Remarks

S.N. 09/885,130

Amendments to the Drawings

FIG. 7

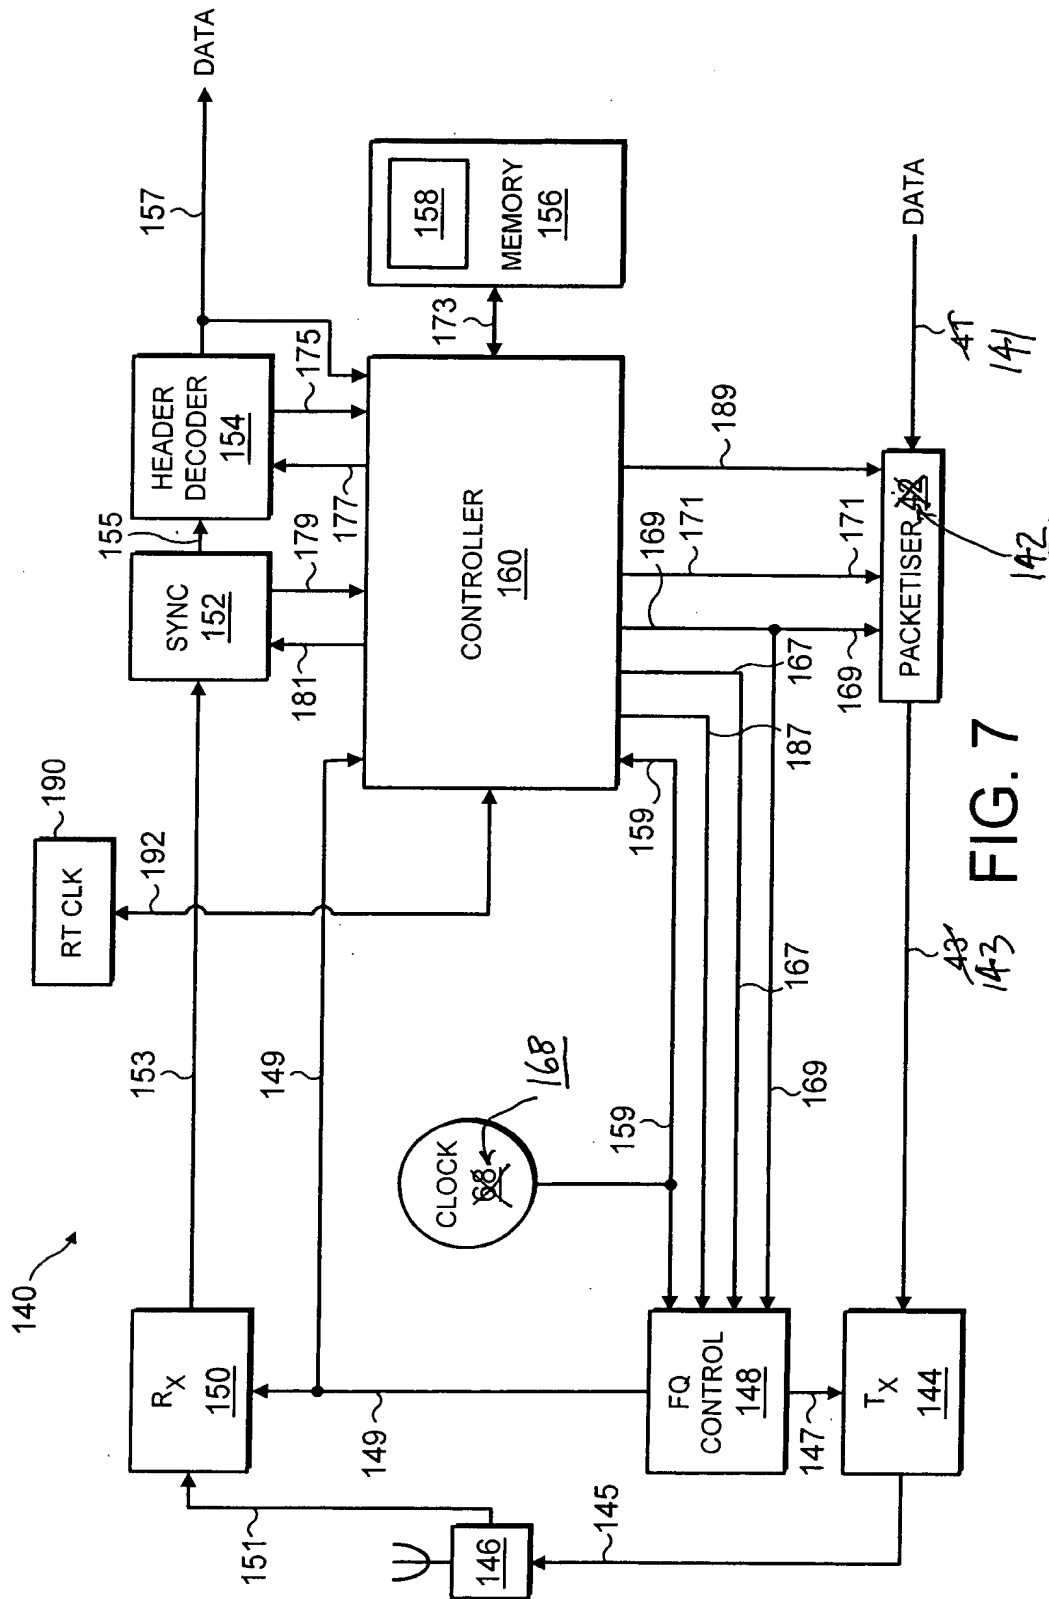
Acceptance, also, of the replacement drawing sheet for Sheet 5/6, directed to Fig. 7 of the drawings, is respectfully requested. The changes formally made thereto, as explained hereinabove, are directed to minor formal matters. This should clearly become apparent from the accompanying annotated illustration in conjunction with the related description thereof, in the Specification.

The attached single replacement sheet (sheet 5/6) includes changes to Fig. 7. Namely, four (4) of the reference characters in Fig. 7 are being amended so as to conform to the corresponding reference characters referred to in the Detailed Description of the Specification. The noted changes are illustrated in red in the accompanying annotated sheet.
